April 9, 2016

03120 Version 5

Safety Recall: 2008–10 Accord SRS Unit ReplacementSupersedes 16-006, dated March 17, 2016 to revise the information highlighted in **yellow****AFFECTED VEHICLES**

REVISED IMAGE

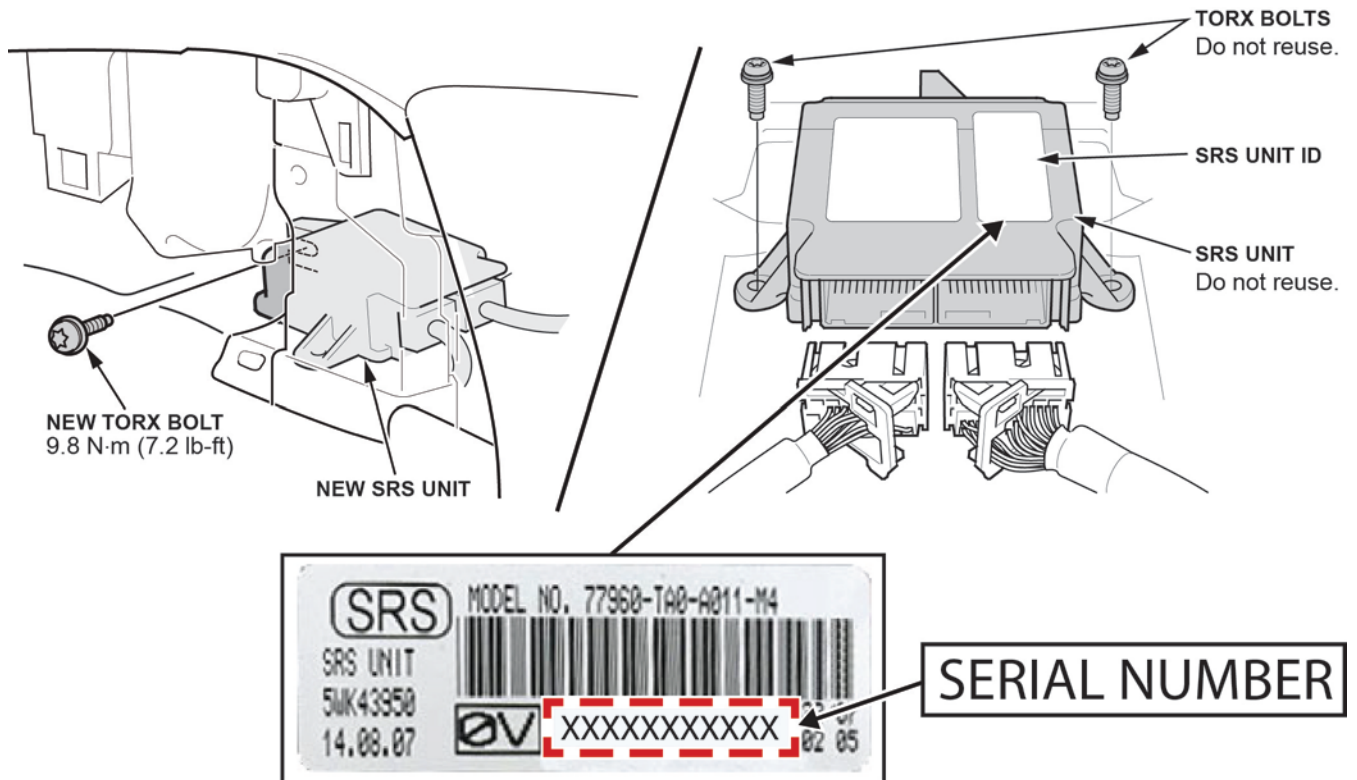
REVISION SUMMARYAn image was added to show the location of the serial number in **REPAIR PROCEDURE**.**BACKGROUND**

7. Write down the new SRS unit ID (serial number) on the RO, then install the new SRS unit using the new Torx bolts.
NOTE: Make sure the SRS unit is sitting squarely against its bracket before torquing the Torx bolts.
